RUSSELL VALE COLLIERY

Response to Planning Assessment Commission Review Report Part 1

**RUSSELL VALE COLLIERY
UNDERGROUND EXPANSION PROJECT**

**RESPONSE TO
PLANNING ASSESSMENT
COMMISSION REVIEW REPORT
– PART 1**

Indicative Infrastructure Layout

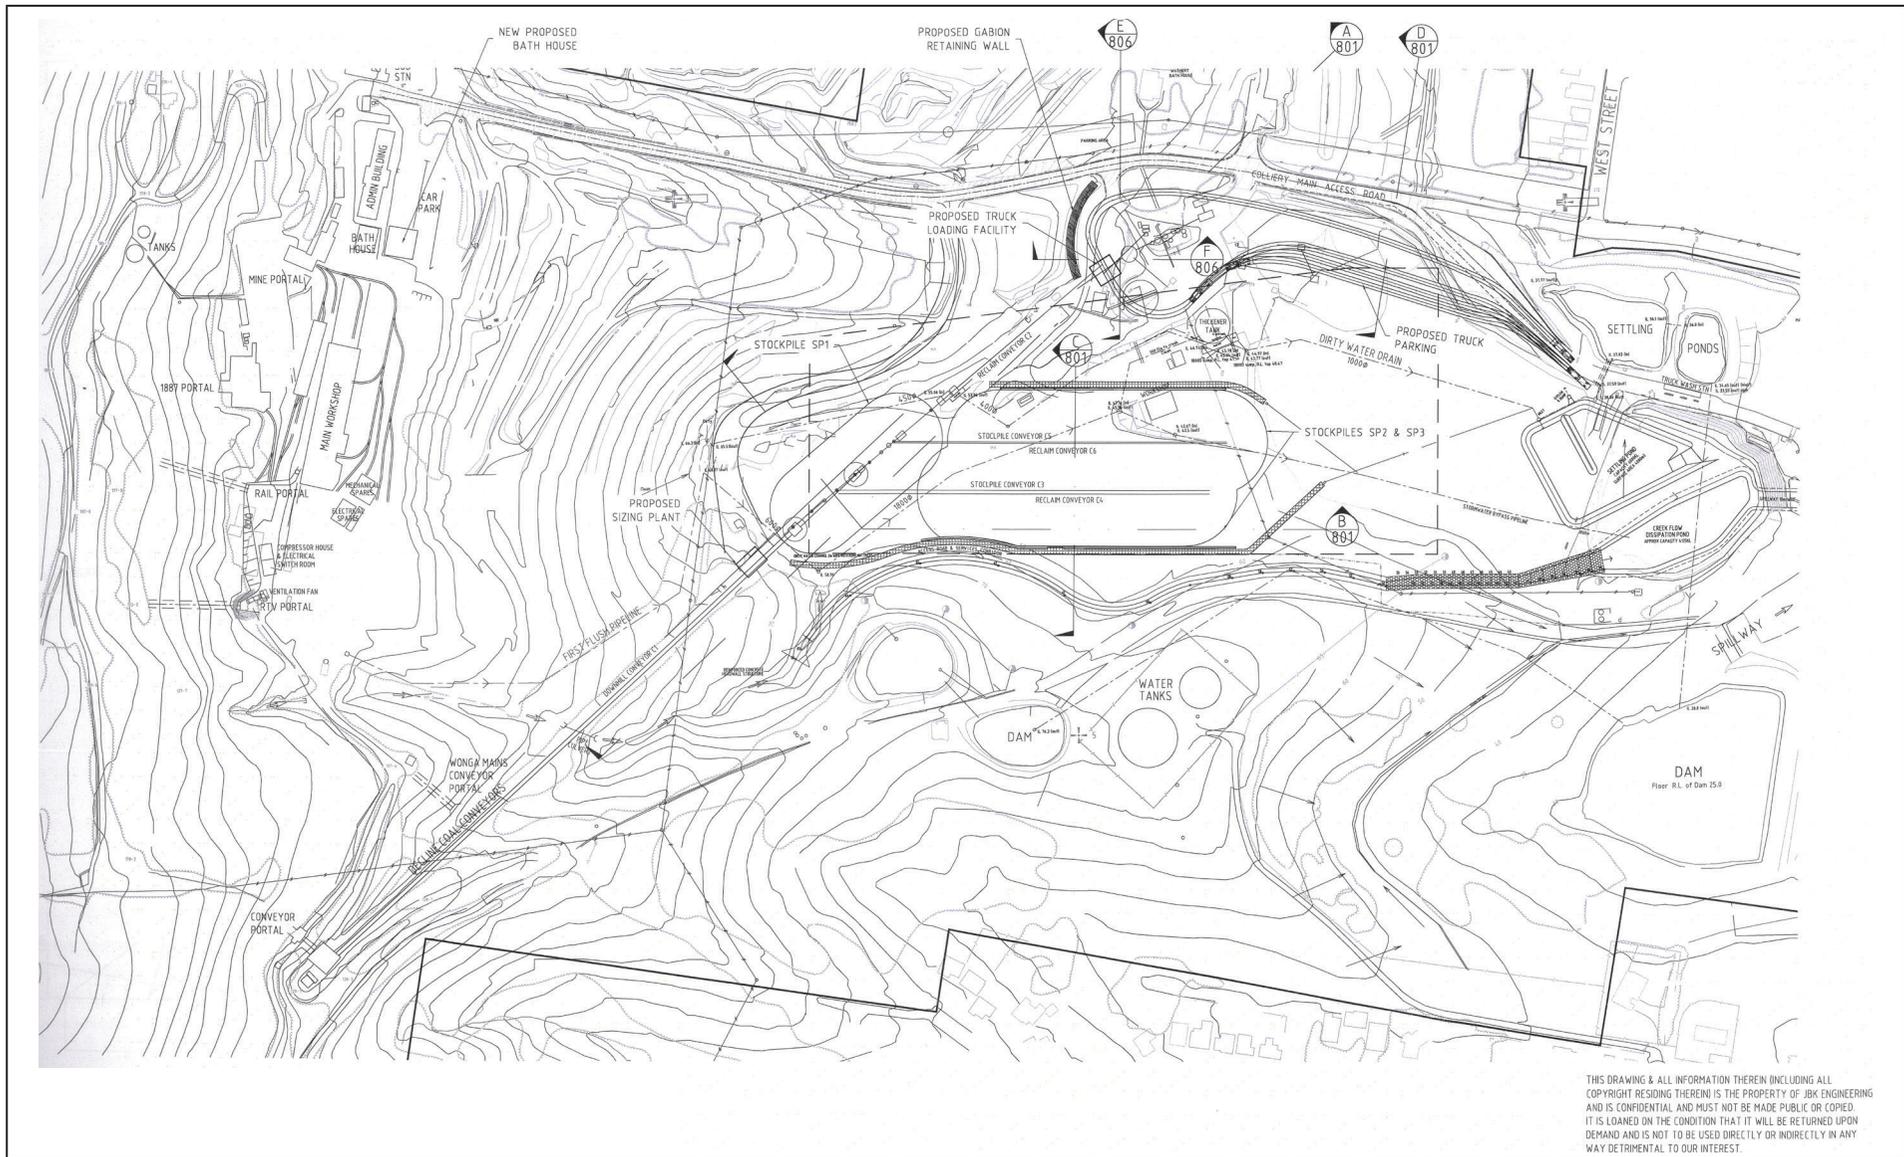
- a. construction of a coal truck parking area (for trucks to wait prior to the commencement of haulage hours) within the mine boundary;*
- b. construction of a noise barrier near the intersections of Bellambi Lane/Princes Highway and Bellambi Lane/Northern Distributor; and*
- c. use of pavement modifications along Bellambi Lane to reduce truck/trailer banging.*

WCL will also pave the proposed haul road through the stockpile area (as shown in **Figure 3**).

- a. A parking area for haul trucks is proposed as a component of the Project and is illustrated in the Environmental Assessment (ERM, 2013). The location of the parking area for which approval is sought is shown in **Figure 3**.
- b. Construction of a noise barrier near the intersections of Bellambi Lane/Princes Highway is considered in Section 7 of **Appendix B**. It demonstrates that taking receiver heights into account, it is considered that the only the section of the site boundary shown in **Figure 1** would benefit from a barrier (which does not include the intersection).

Figure 7-7: Section of Site Boundary that may benefit from 6m High Barrier

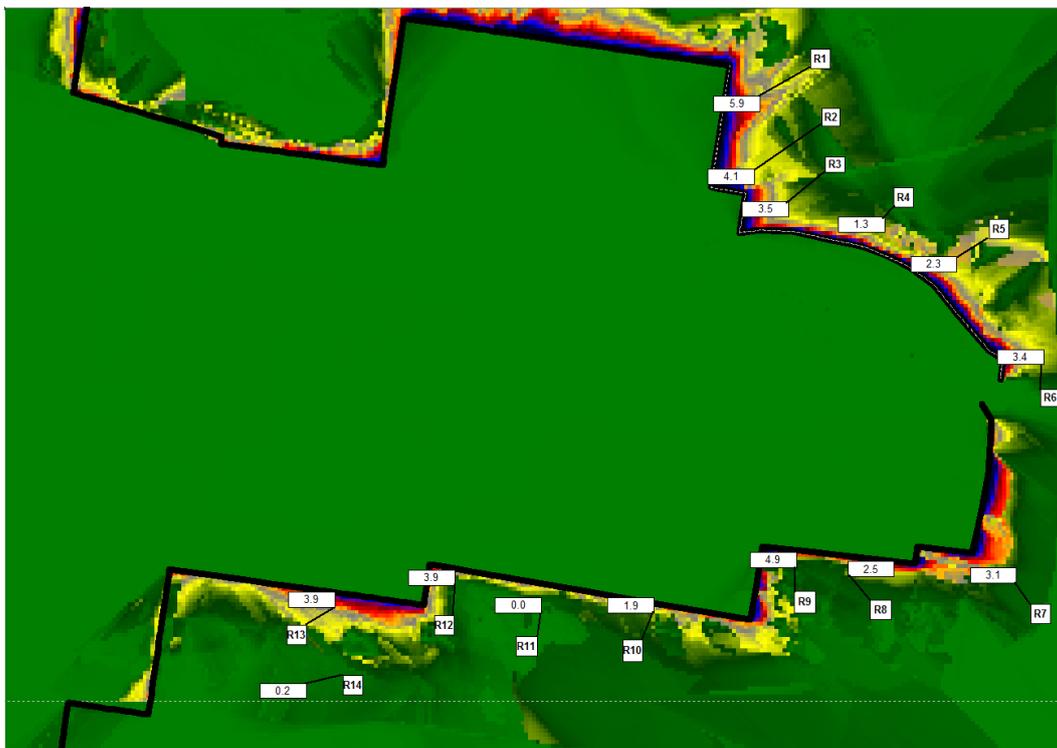
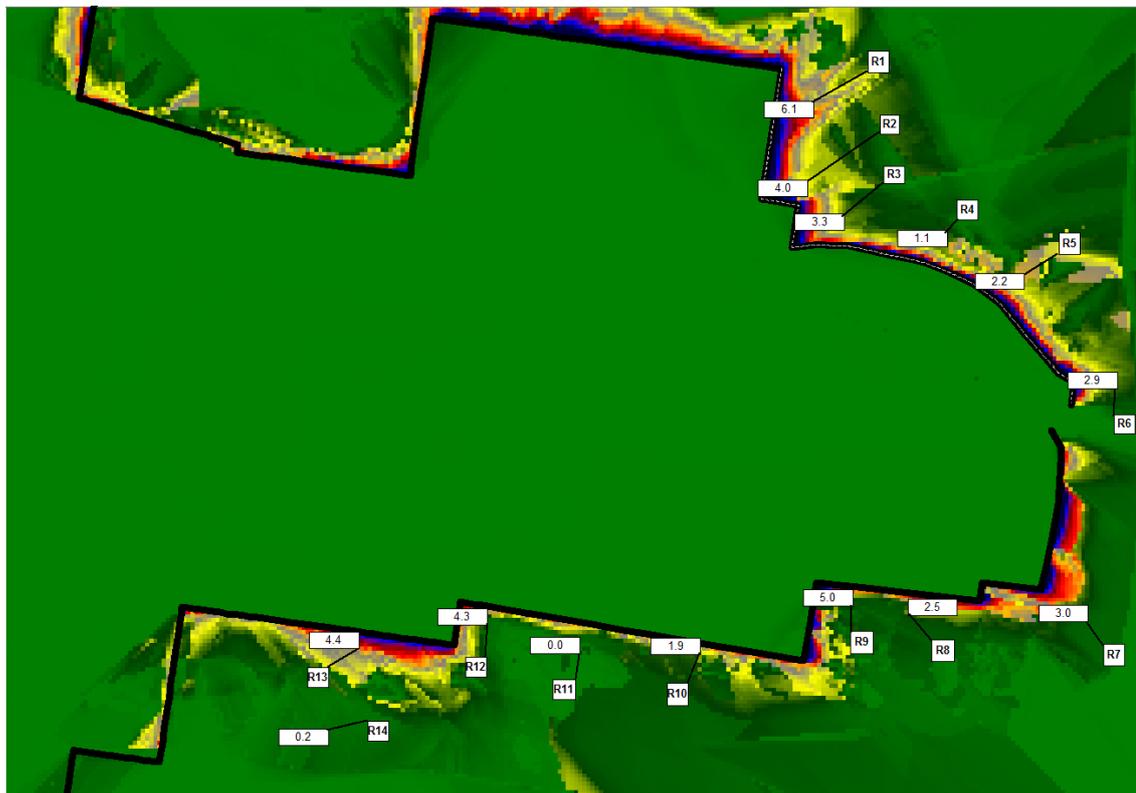
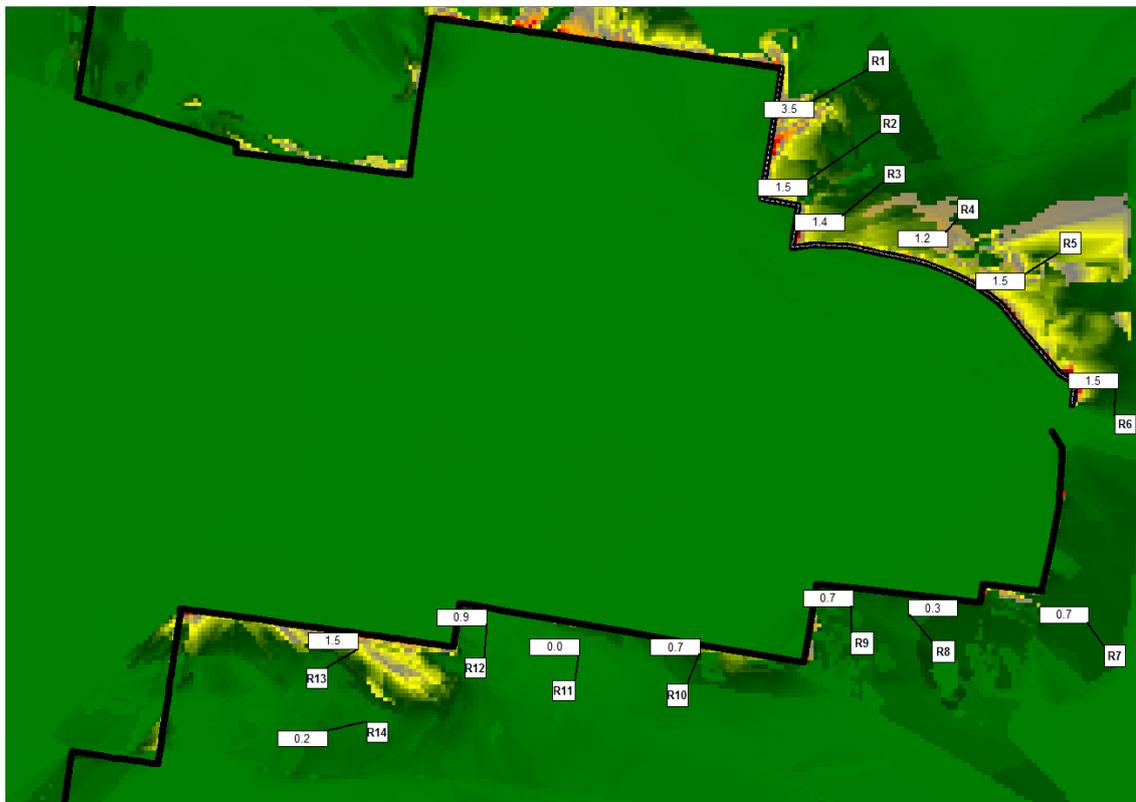
Figures 6-2 and 6-3 show predicted barrier attenuation maps under neutral meteorological conditions for barriers of 4 m and 6 m established around the entire perimeter of the site.

Figures 6-4 and 6-5 show predicted barrier attenuation maps under adverse meteorological conditions for barriers of 4 m and 6 m established around the entire perimeter of the site.

These maps show the predicted barrier loss at 1.5 m above ground level and therefore represent the attenuation expected to be achieved for single storey receivers. The predicted attenuation levels (at 1.5 m above ground level) at Receivers R1-R14 are shown on the figures. Significantly lower levels of attenuation may be expected for receivers with upper storeys. Figure 7-6 shows the attenuation that may be expected for second storey receivers.

Modelling results indicate that given the natural topography of the site, barriers of substantial height (e.g. approximately 6 m) would be necessary to achieve attenuation of material acoustic benefit. In this regard it should be noted that attenuation levels of 1-2 dB would not be expected to provide any real benefit as such reductions are not particularly noticeable to most people. WM considers that 3-5 dB is the minimum level of attenuation that should be achieved for there to be material acoustic benefit of installing a barrier.

In considering the efficacy of a barrier, attention to the receiver height should be a consideration. In this regard it should be noted that the receivers to the north and north-west of the site (including R1-R7) are noted to be predominantly single storey dwellings, whereas the receivers to the south are mainly two storey dwellings. Taking receiver heights into account, it is considered that the only a limited section of the site boundary would benefit from a barrier, this section is shown in Figure 7-7. Such a barrier would be approximately 280m long.

Whilst modelling indicates that a barrier established on a limited section to the site boundary may provide some acoustic benefit, WM would recommend that a program of real-time noise monitoring is undertaken prior to installing any such barrier. The monitoring would be expected to provide further confidence in the actual noise levels arising due to the on-site activities in the vicinity of the proposed barrier location as indicated in Figure 7-7.
